PILATUS AIRCRAFT LTD. CH-6371 STANS, SWITZERLAND

SERVICE LETTER

SUBJECT: GOODRICH POWER SYSTEMS DC STARTER/GENERATOR SERVICE BULLETINS 23085-025-24-1 AND 23085-024-24-01

ELECTRICAL POWER - DC STARTER-GENERATOR
DRIVE SHAFT ISOLATION - CONVERSION OF MODEL 23085-024
TO MODEL 23085-030

Figure 1 - Location of Heli-Coils in the Anti-Drive End (ADE) End Bell

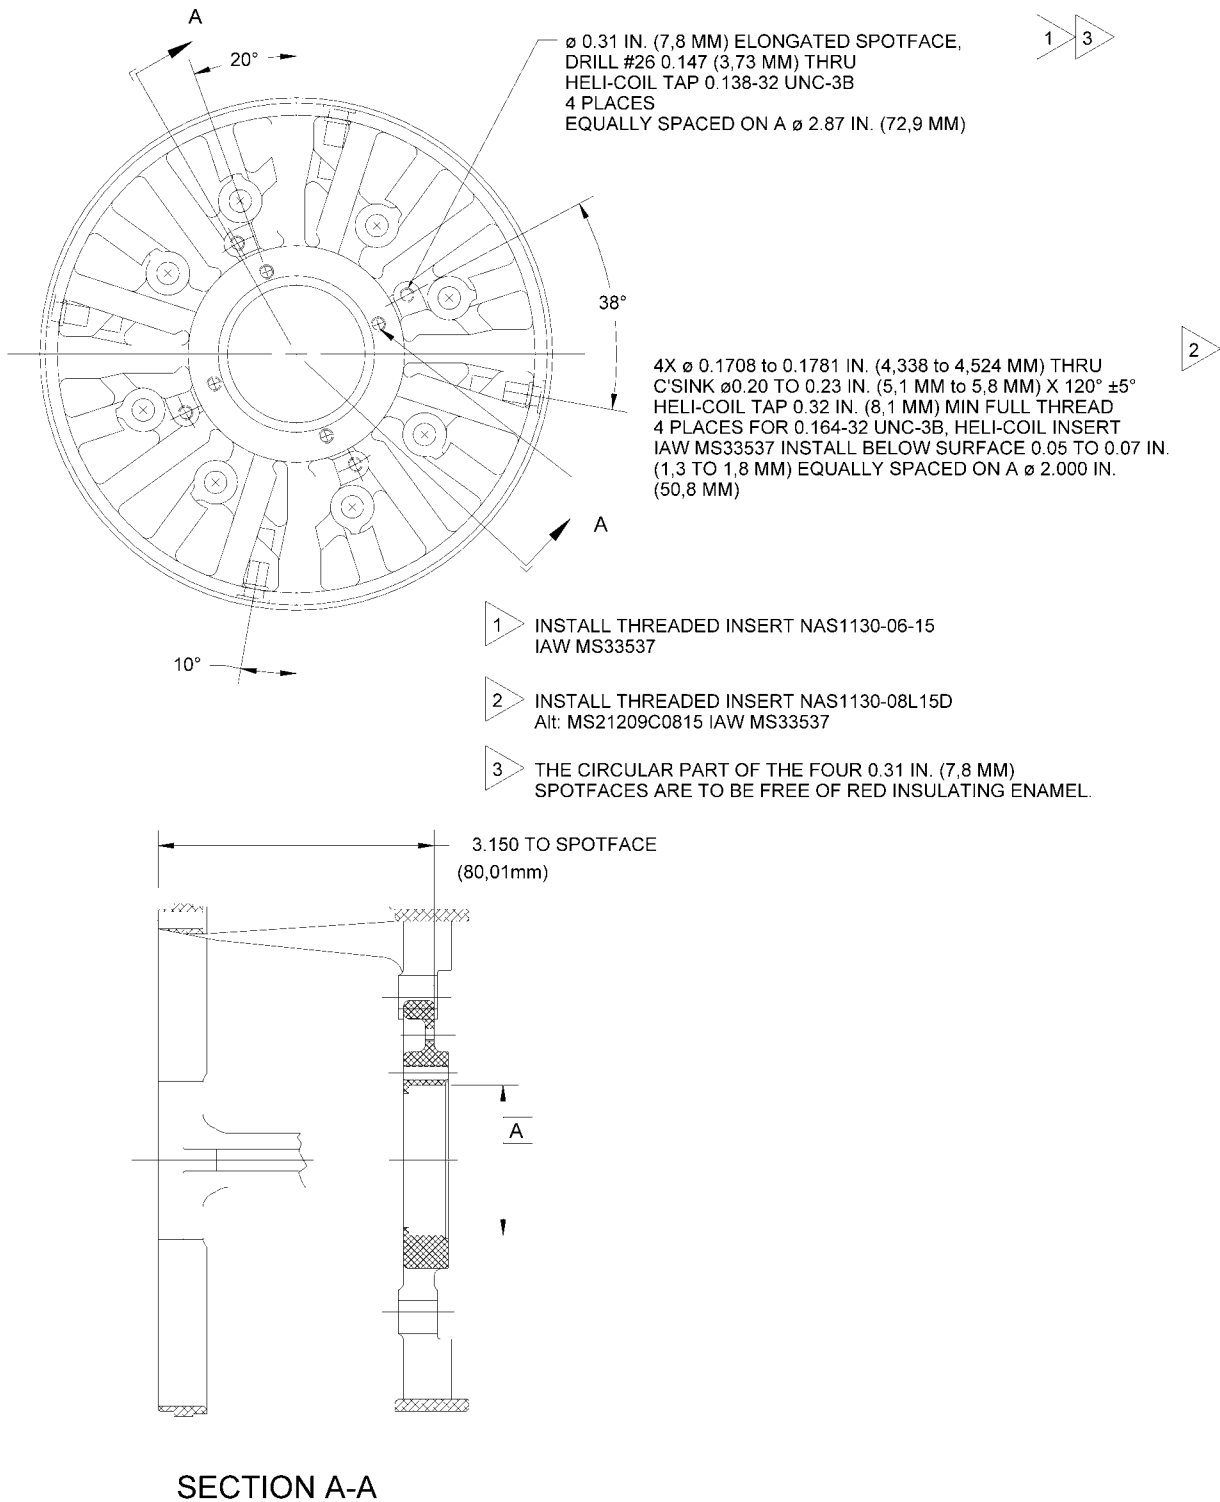
- (1) Refer to the REPAIR section of the referenced CMM and SPD (Standard Practice Document) 1003 for removal of surface coatings.
- (2) If required, install threaded inserts (heli-coils), (P/N NAS1130-06-15) into ribs, as shown in [Figure 1](#) and as follows:
 - (a) Elongated spotface, if not already included, a 0.31 inch (7,8 mm) diameter located 38° counter-clockwise from the rivnuts to a depth of 3.15 inch (80,0 mm) from the opposite end of the ADE end bell located on a 2.87 inch (72,9 mm) diameter.

- (b) Drill through on a bolt circle diameter of 2.87 inch (72,9 mm) with #26 0.147 inch (0,37 mm) drill bit.
- (c) Tap through for 0.138-32 UNC-3B using 06CPB heli-coil tap, four places equally spaced on a bolt circle diameter of 2.87 inch (72,9 mm).
- (d) Clean each hole for threaded inserts by removing burrs or raised metal.

- (e) Coat four new (P/N NAS1130-06-15) heli-coil inserts with zinc chromate primer and install them while wet into the rib screw holes.

- (3) If required, install threaded inserts (heli-coils), (P/N NAS1130-08L15D, Alt: MS21209C0815) into bearing retainer screw holes, as shown in [Figure 1](#) and as follows:
- (a) Drill through with a 0.1708 to 0.1781 inch (4,338 to 4,524 mm) drill bit. The four holes are located on a 2.000 inch (50,8 mm) basic diameter. See [Figure 1](#).
 - (b) Countersink the bearing retainer screw holes 115° to 125° to a 0.20 to 0.23 inch (5,1 to 5,8 mm) diameter.
 - (c) Tap 0.164-32 UNC-3B using a 2CPB heli-coil tap.
 - (d) Clean each hole for threaded inserts by removing burrs or raised metal.

- (e) Coat four new P/N NAS1130-08L15D (Alt. MS21209C0815) heli-coil inserts with zinc chromate and install them into the bearing retainer screw holes to a depth of 0.05 to 0.07 inch (1,3 to 1,8 mm) below the counterbore surface. This measurement is to the start of the heli-coil wire. Break off the tang if required.

Figure 6 - Assembly of ADE Drive Shaft Isolation

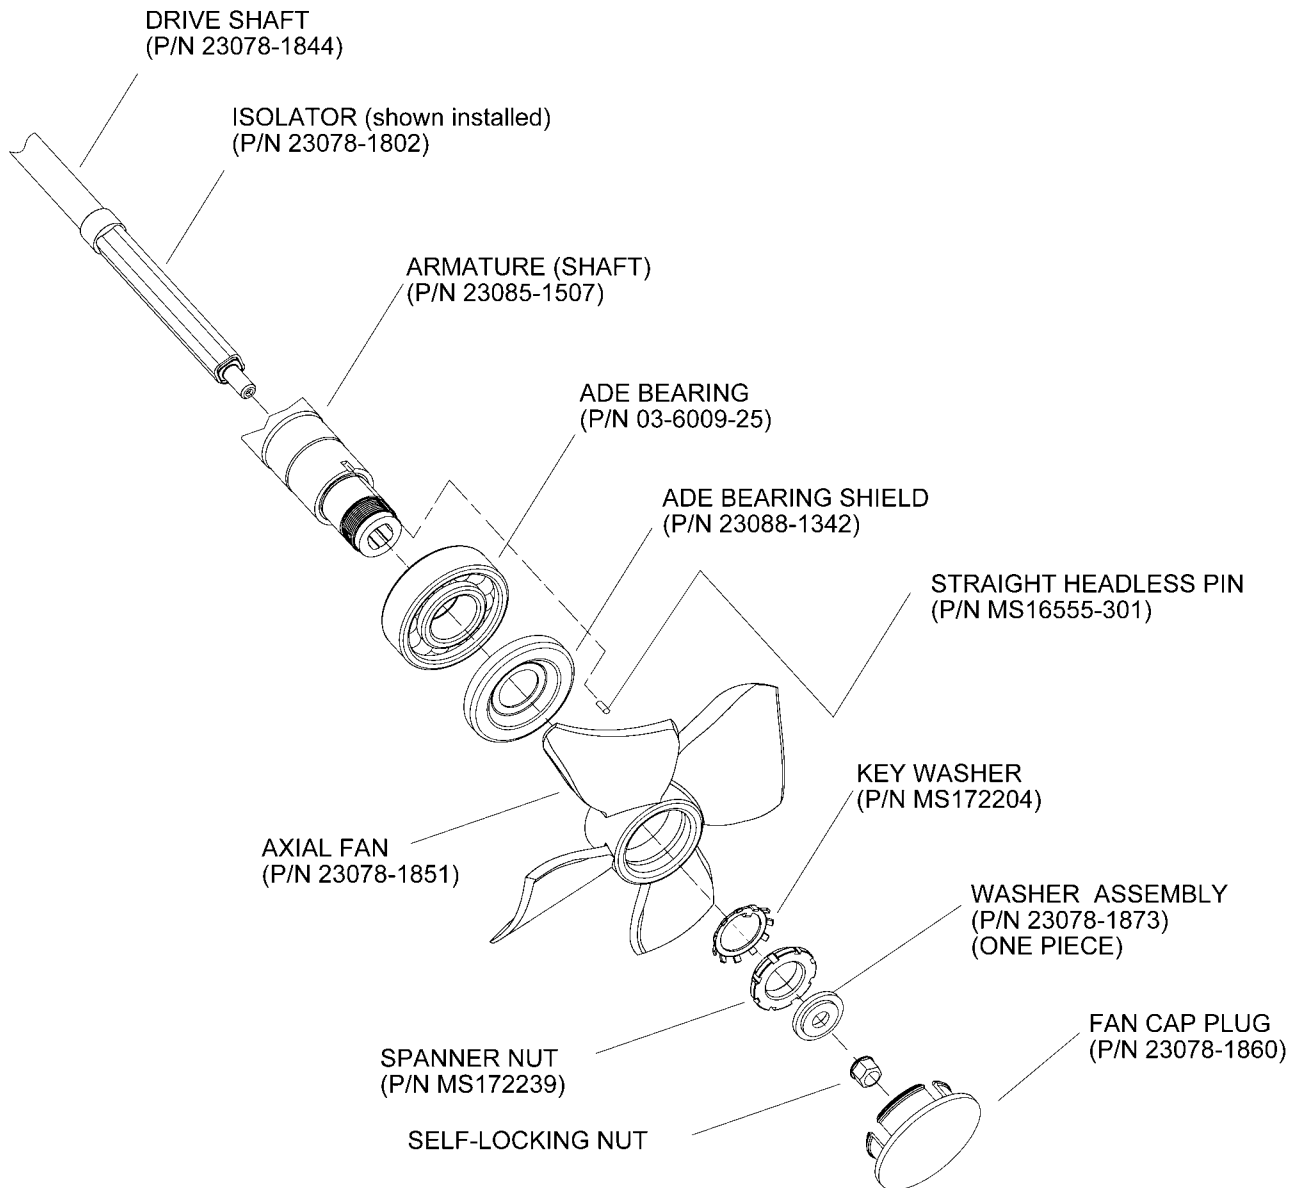
- (12) Install drive shaft (P/N 23078-1844) with isolator (P/N 23078-1802), ADE bearing shield (P/N 23088-1342) and axial fan (P/N 23078-1851) as follows. See [Figure 5](#) and [Figure 6](#).
- (a) Slide isolator (P/N 23078-1802) onto the drive shaft square spline until the isolator (P/N 23078-1802) is flush against the drive shaft square spline shoulder. See [Figure 5](#).
 - (b) Insert drive shaft (P/N 23078-1844) through the armature shaft. Make sure that drive shaft square spline engages armature shaft spline and that friction ring (P/N 02-5600-17) is correctly positioned on dampener back plate.

- (d) Attach key washer (P/N MS172204) on armature shaft as shown in [Figure 6](#), locate key washer (P/N MS172204) on armature shaft by aligning the key washer inner tab with the armature keyway.

- (k) Press the fan cap plug (P/N 23078-1860) onto the fan. See [Figure 6](#) for proper orientation.

Figure 11 - Replacement Identification Plate

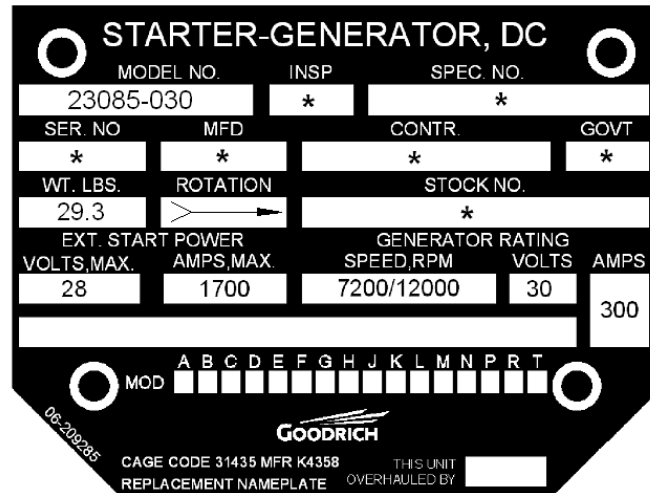
- (a) Remove the old identification plate as given in paragraph [3.B.\(2\)](#).
- (b) Put the replacement identification plate (P/N 06-209285) on a wood backing surface and metal stamp or vibra etch the MODEL NO., WT. LB., ROTATION, VOLTS MAX, AMPS MAX, SPEED RPM, VOLTS and AMPS as shown in [Figure 11](#).

NOTE: Identify this unit as a 23085-030.

NOTE: Do not transfer modification status stamping from the 23085-024 identification plate.

Figure 1 - Location of Heli-Coils in the Anti-Drive End (ADE) End Bell

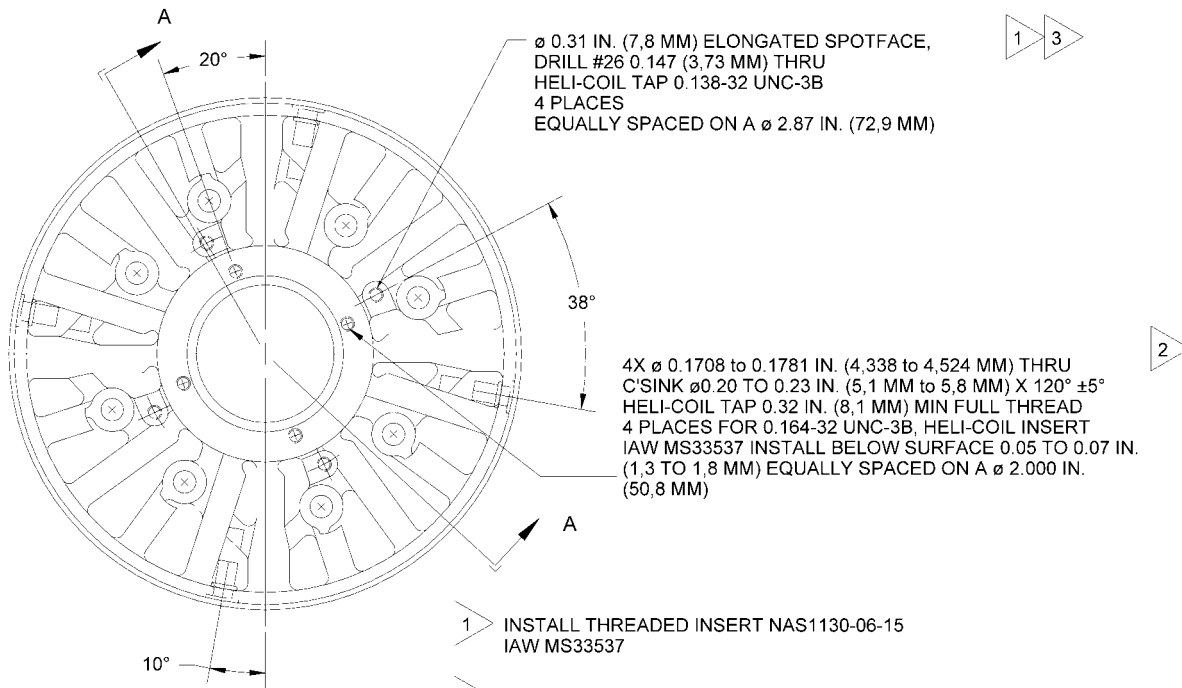
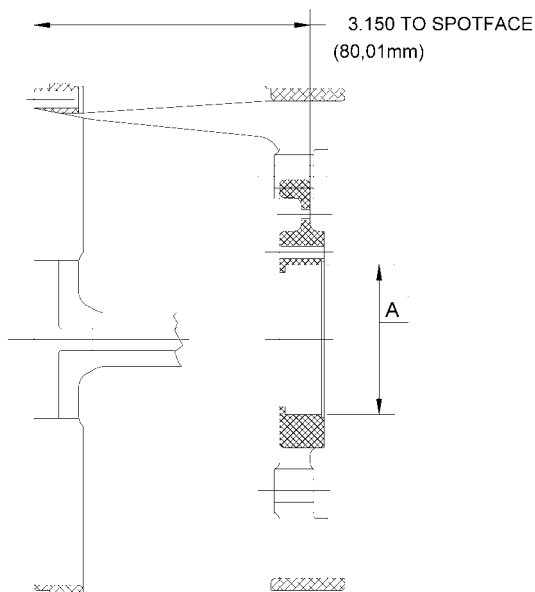
- (1) Refer to the REPAIR section of the referenced CMM and SPD (Standard Practice Document) 1003 for removal of surface coatings.
- (2) If required, install threaded inserts (heli-coils), (P/N NAS1130-06-15) into ribs, as shown in [Figure 1](#) and as follows:
 - (a) Elongated spotface, if not already included, a 0.31 inch (7,8 mm) diameter located 38° counter-clockwise from the rivnuts to a depth of 3.15 inch (80,0 mm) from the opposite end of the ADE end bell located on a 2.87 inch (72,9 mm) diameter.

- (b) Drill through on a bolt circle diameter of 2.87 inch (72,9 mm) with #26 0.147 inch (0,37 mm) drill bit.
- (c) Tap through for 0.138-32 UNC-3B using 06CPB heli-coil tap, four places equally spaced on a bolt circle diameter of 2.87 inch (72,9 mm).
- (d) Clean each hole for threaded inserts by removing burrs or raised metal.

- (e) Coat four new (P/N NAS1130-06-15) heli-coil inserts with zinc chromate primer and install them while wet into the rib screw holes.

- 1 INSTALL THREADED INSERT NAS1130-06-15 IAW MS33537
- 2 INSTALL THREADED INSERT NAS1130-08L15D Alt: MS21209C0815 IAW MS33537
- 3 THE CIRCULAR PART OF THE FOUR 0.31 IN. (7,8 MM) SPOTFACES ARE TO BE FREE OF RED INSULATING ENAMEL.

- (3) If required, install threaded inserts (heli-coils), (P/N NAS1130-08L15D, Alt: MS21209C0815) into bearing retainer screw holes, as shown in [Figure 1](#) and as follows:
- (a) Drill through with a 0.1708 to 0.1781 inch (4,338 to 4,524 mm) drill bit. The four holes are located on a 2.000 inch (50,8 mm) basic diameter. See [Figure 1](#).
 - (b) Countersink the bearing retainer screw holes 115° to 125° to a 0.20 to 0.23 inch (5,1 to 5,8 mm) diameter.
 - (c) Tap 0.164-32 UNC-3B using a 2CPB heli-coil tap.
 - (d) Clean each hole for threaded inserts by removing burrs or raised metal.

Figure 6 - Assembly of ADE Drive Shaft Isolation

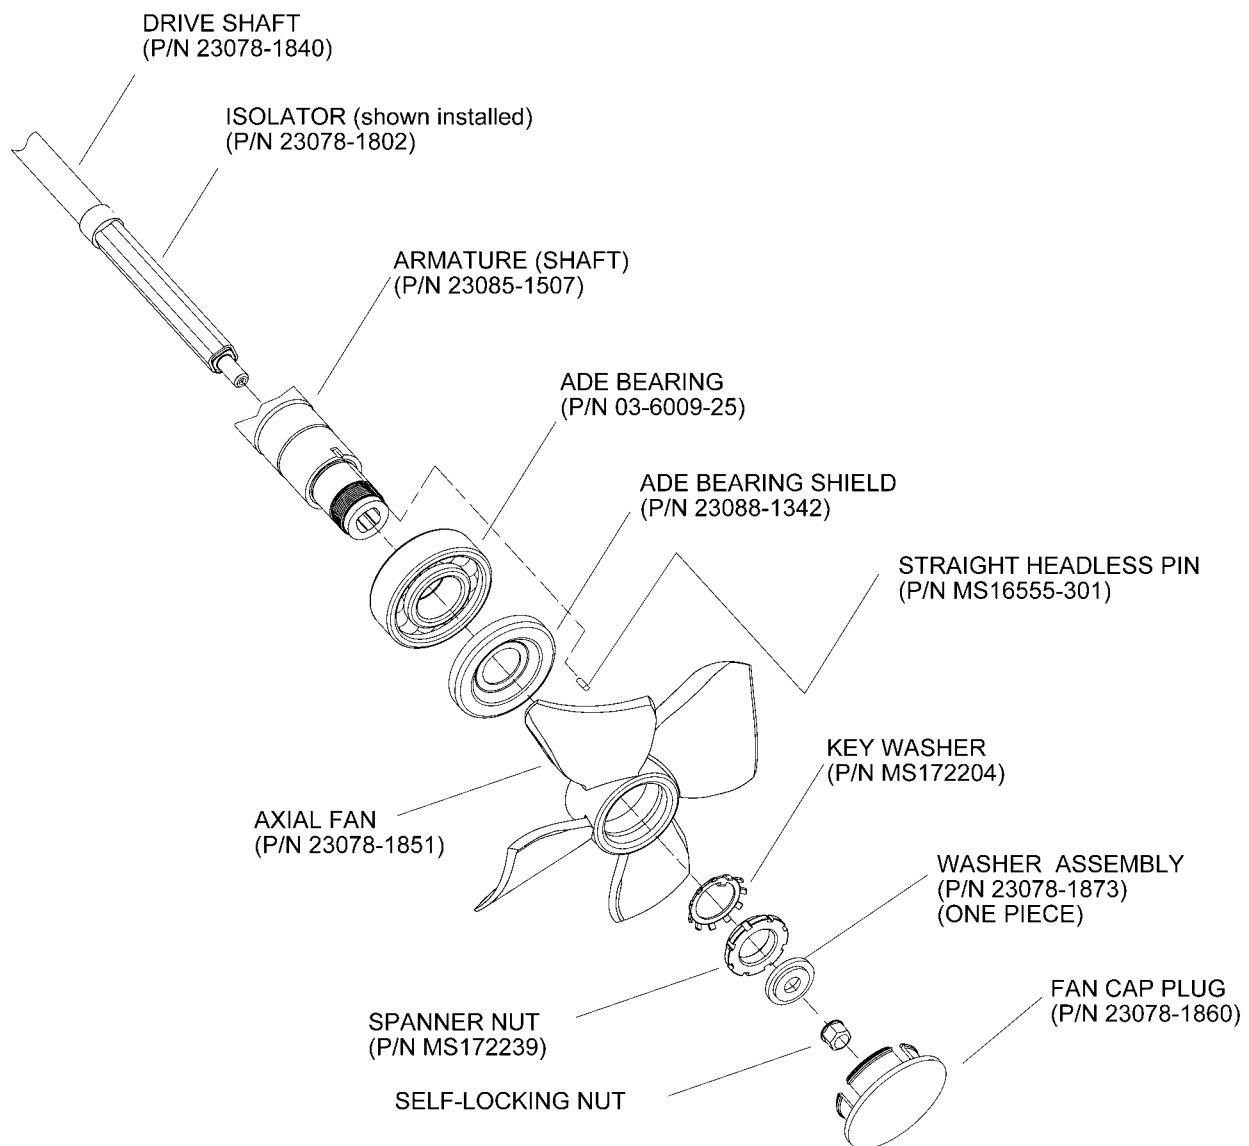
- (12) Install drive shaft (P/N 23078-1840) with isolator (P/N 23078-1802), ADE bearing shield (P/N 23088-1342) and axial fan (P/N 23078-1851) as follows. See [Figure 5](#) and [Figure 6](#).
- (a) Slide isolator (P/N 23078-1802) onto the drive shaft square spline until the isolator (P/N 23078-1802) is flush against the drive shaft square spline shoulder. See [Figure 5](#).
 - (b) Insert drive shaft (P/N 23078-1840) through the armature shaft. Make sure that drive shaft square spline engages armature shaft spline and that friction ring (P/N 02-5600-17) is correctly positioned on dampener back plate.

- (c) Press the fan cap plug (P/N 23078-1860) onto the fan. See [Figure 6](#) for proper orientation.

- (e) Attach key washer (P/N MS172204) on armature shaft as shown in [Figure 6](#), locate key washer (P/N MS172204) on armature shaft by aligning the key washer inner tab with the armature keyway.

Figure 11 - Replacement Identification Plate

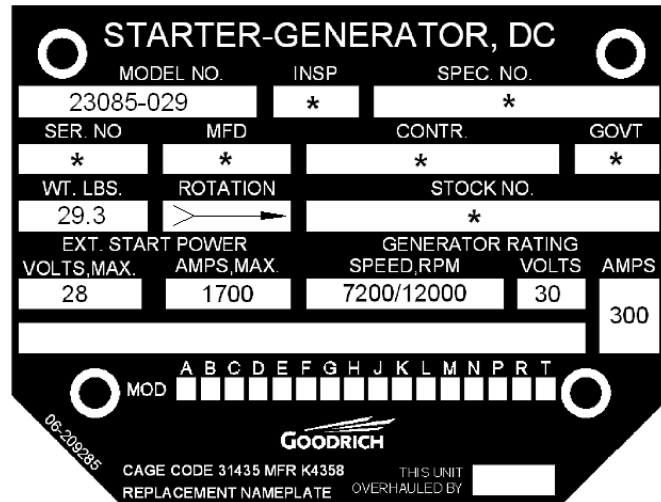
- (1) Re-identify the DC Starter-Generator as follows:
 - (a) Remove the old identification plate as given in paragraph [3.B.\(2\)](#).
 - (b) Put the replacement identification plate (P/N 06-209285) on a wood backing surface and metal stamp or vibra etch the MODEL NO., WT. LB., ROTATION, VOLTS MAX, AMPS MAX, SPEED RPM, VOLTS and AMPS as shown in [Figure 11](#).

NOTE: Identify this unit as a 23085-029.

NOTE: Do not transfer modification status stamping from the 23085-025 identification plate.
